MEMORANDUM

TO: Cape Elizabeth Planning Board
FROM: Maureen O'Meara, Town Planner
DATE: May 19, 2020
SUBJECT: 287 Ocean House Rd Village Retail Site Plan

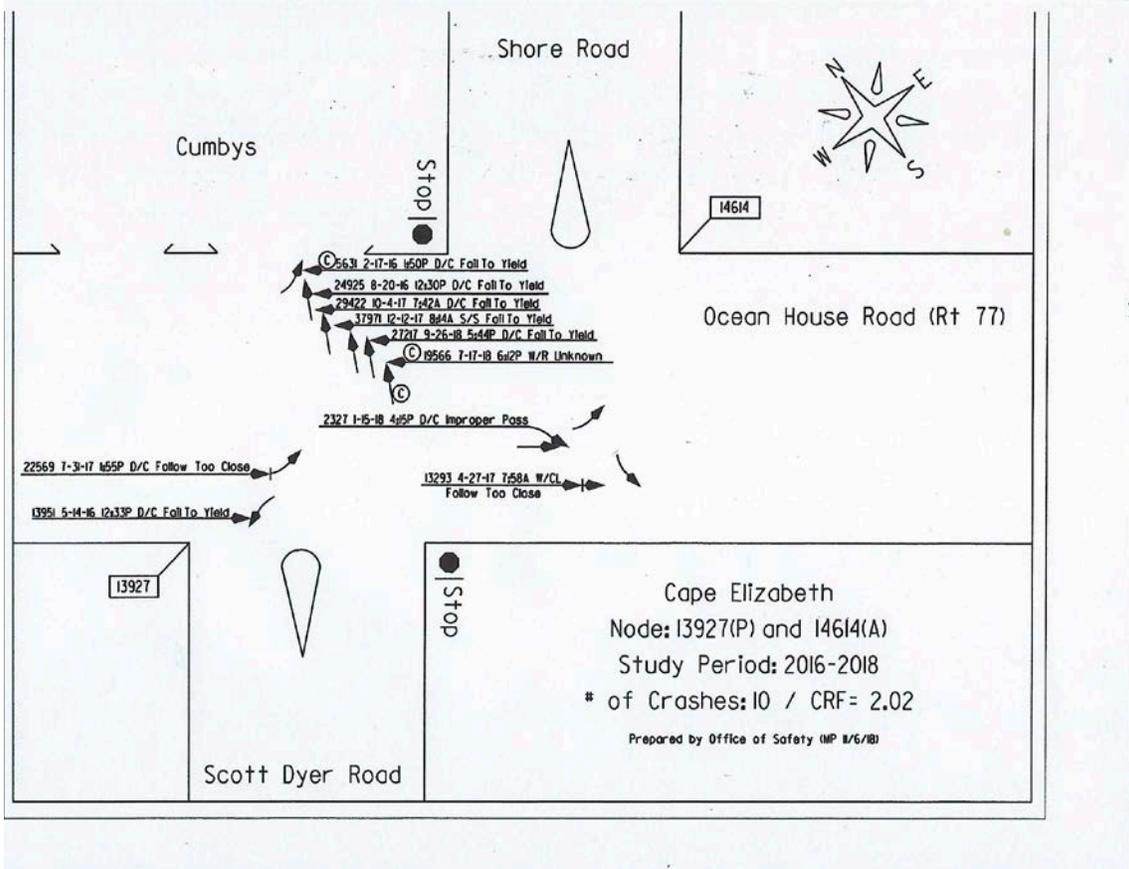
- a. Adequacy of Road System- The applicant has submitted a Traffic Assessment prepared by William Bray of Traffic Solutions. The project will add 2-4 trips to the adjacent Ocean House Rd/Shore Rd/Scott Dyer Rd intersection during the weekday peak hour and up to 14 trips during the Saturday peak hour. These trips will be added to an intersection that has been designated by the Maine Department of Transportation (MDOT) as a High Crash Location (HCL) for the 2016-2018 reporting period. Below is the drawing produced by MDOT depicting the crash history.

The report recommends that "Additional study of the intersection is recommended to establish what level of mitigation is appropriate in reducing the higher than expected number of left-turn crashes in the intersection."

The Planning Board may want the applicant to propose mitigation for the increased traffic it will contribute to the intersection.

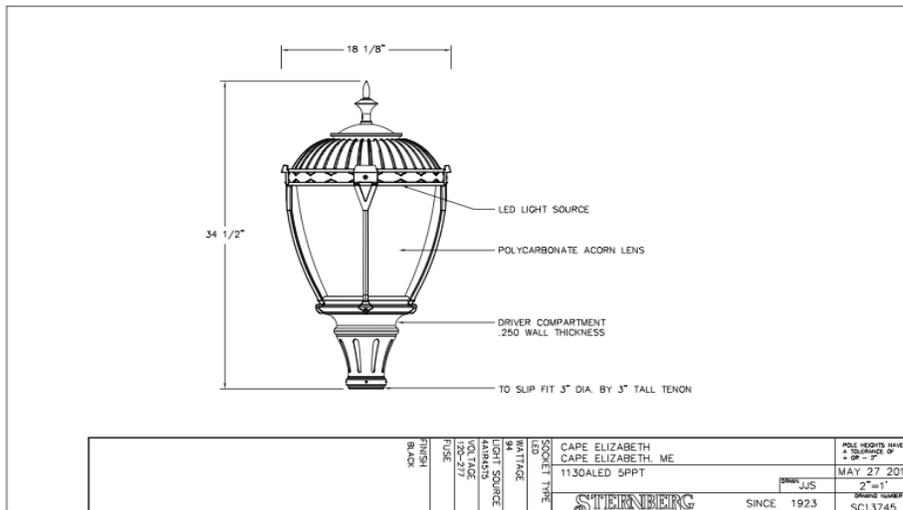
The site and immediately surrounding road right-of-way includes several trees and mature shrubs. A preservation plan for existing vegetation should be provided to protect vegetation during construction.

The applicant proposes to keep existing plantings and add 5 black tupelo trees (species approved by the Tree Warden).

7. That the landscape plan be revised to show a continuous shrub and tree buffer of the parking lot from the public road;
8. That a preservation plan for the existing vegetation to be preserved be added to the plans;
